Product Change Notice (PCN)

PCN Number: PCN-0334014R-01

Product(s) Affected: *CMR-2747PB-A*

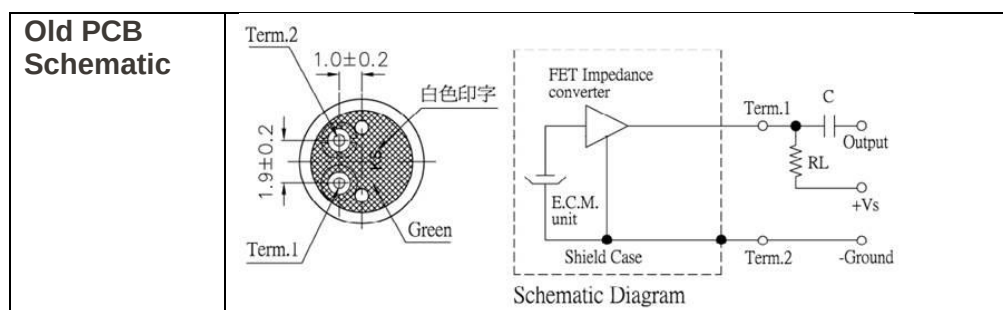
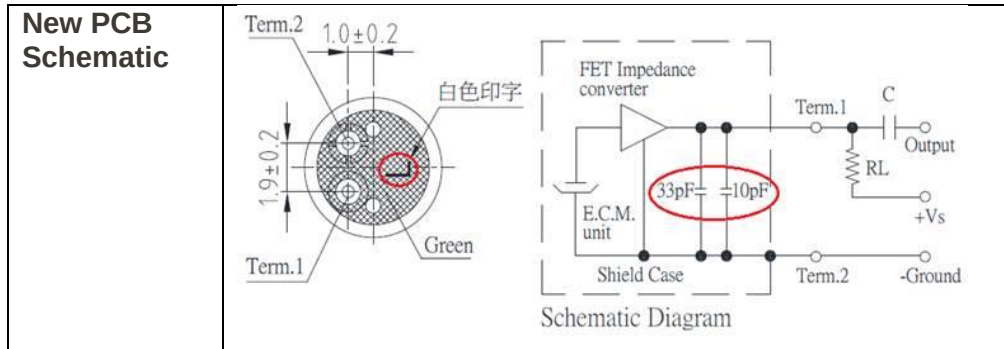
Reason(s) for Change: *PCB update.*

Description of Change: *PCB changed and capacitors 10PF & 33PF added for anti-interference.*
